January 31, 2005

Re: Giant Bloomfield Refinery – NMED Conditional Approval of River Terrace Area
Voluntary Corrective Measures Plan
RCRA Permit No. NMD 089416416
HWB-GRCB-04-006

Response to NMED Conditions of Approval

MW-48 and MW-49 Construction Diagram and Boring Log

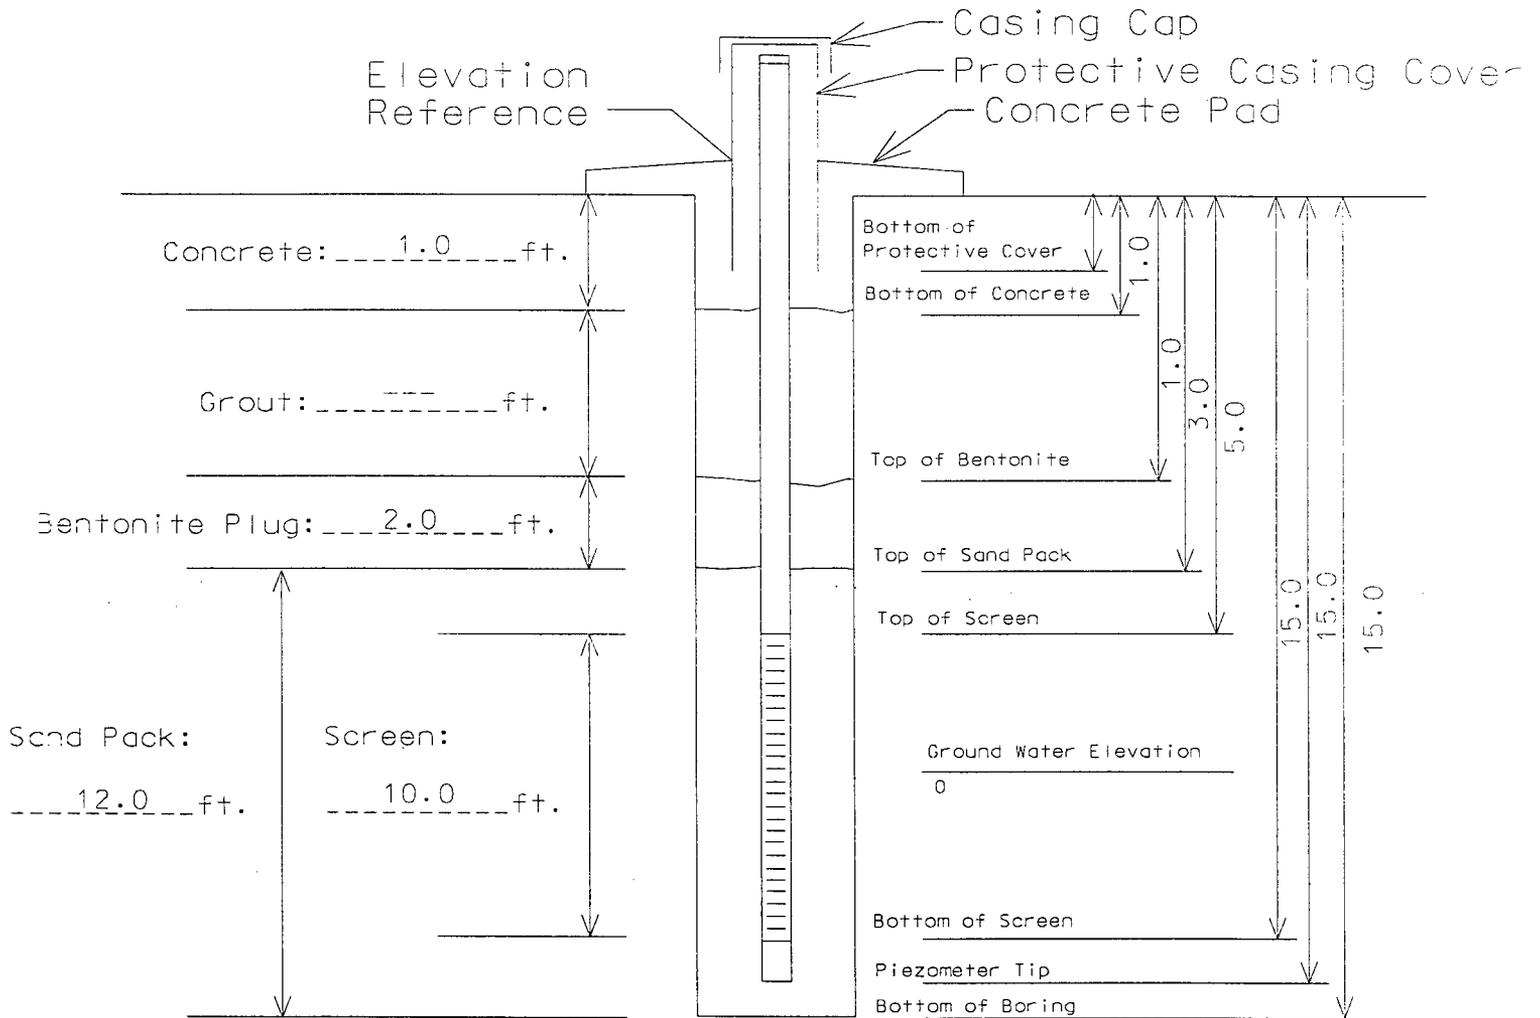
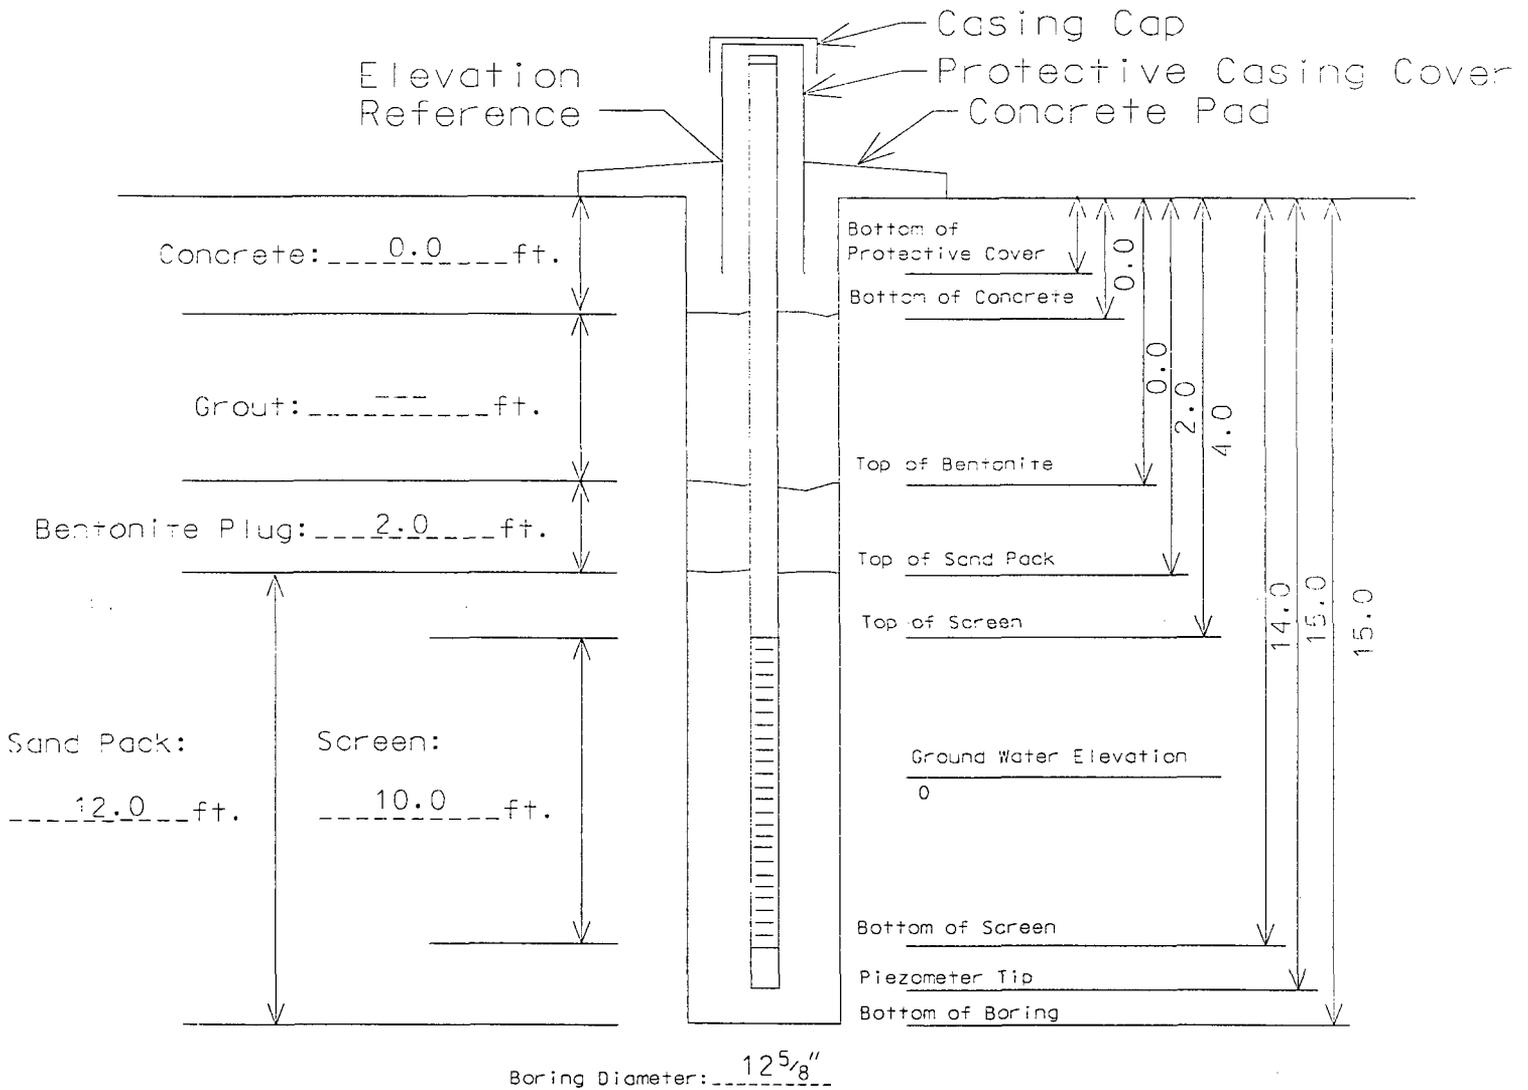
1. We have provided the construction diagram and boring log for monitoring wells MW-48 and MW-49 (Attachment A).
2. Depth-to-water measurements were collected following the installation of the two monitoring wells and eight temporary well points in November 2004 (Attachment B). A survey of each River Terrace well location and top-of-casing elevation will be completed following the installation of the additional well points east of TP-3 (See Response #7). Once surveying of the River Terrace wells has been completed, groundwater elevation data will be compiled and submitted to NMED as requested.

Typical Temporary Well Point Construction Drawing

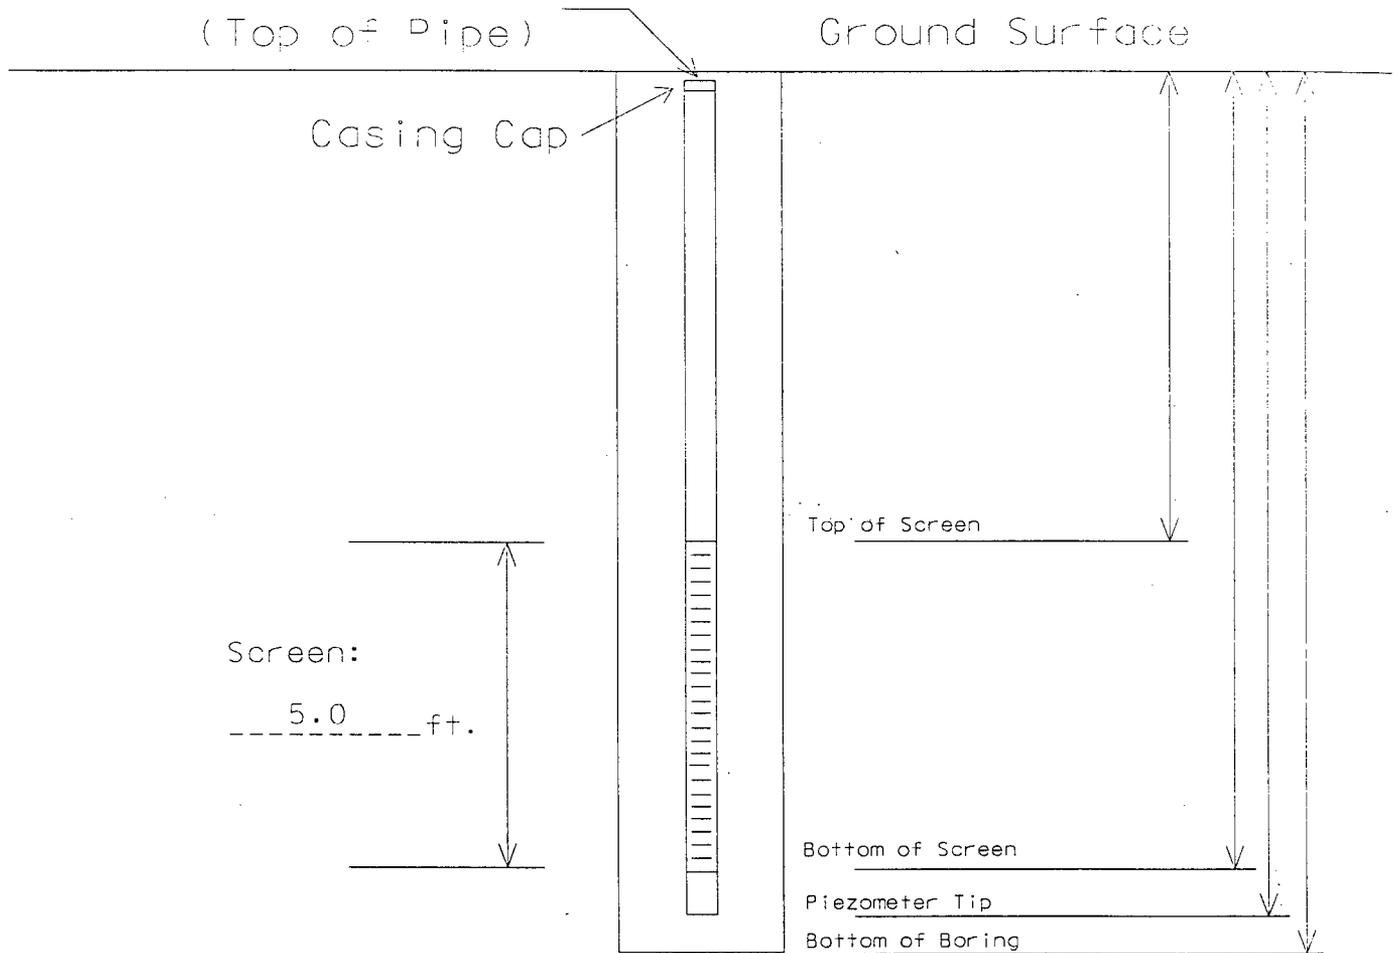
3. Each of the eight temporary well points (TP-1 through TP-8) was constructed using two-inch diameter five-foot hand-slotted PVC piping, extending approximately five feet below the water table. Groundwater has been detected approximately five feet below existing grade. We have provided a typical temporary well point construction drawing (Attachment C). The depth to water (bgs) in each of the locations is stated in the upper left header of the logs contained in the VCM plan.

River Terrace Well Location Map

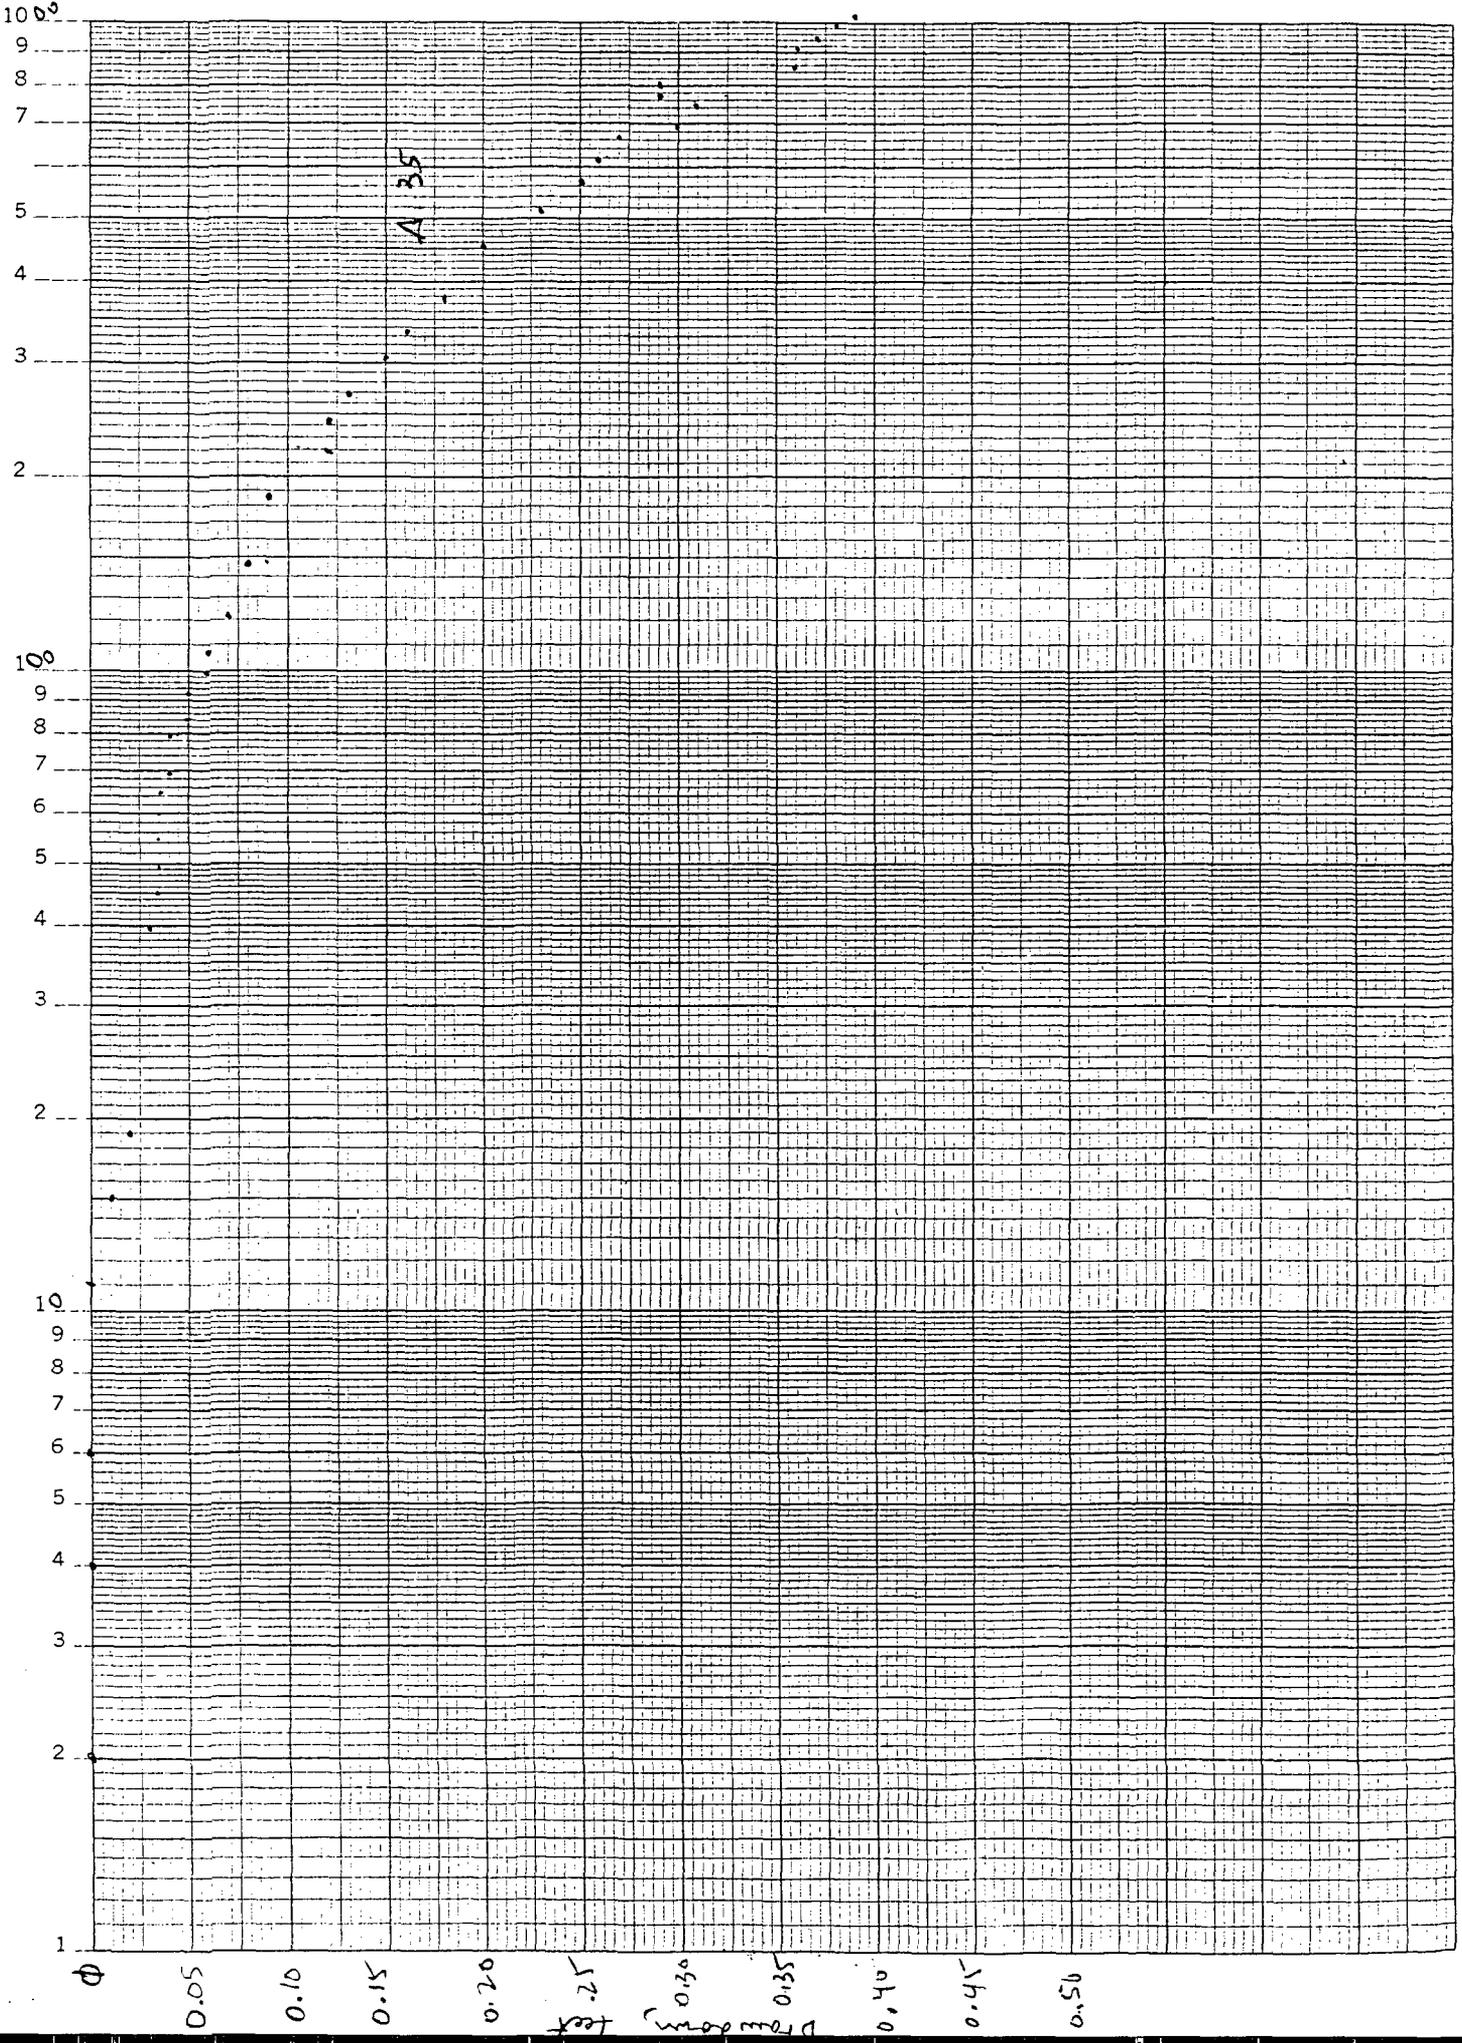
7. In order to delineate the extent of the contamination north and east of TP-3, we propose installing five additional temporary well points (TP-9 through TP-13). We have provided a revised River Terrace Well Location Map, which includes the location of the existing and proposed monitoring and temporary well points in the River Terrace (Attachment E). The well points will be constructed using machine-slotted screen. Weather and access conditions permitting, GRCB anticipates installing the additional well points by early March 2005.

2. The results of the capture zone analysis are summarized as part of the Aquifer Test Summary Report (Attachment F).
 3. A revised Well Location Map has been provided, which includes the location of the existing and proposed monitoring and temporary well points in the River Terrace (Attachment E).
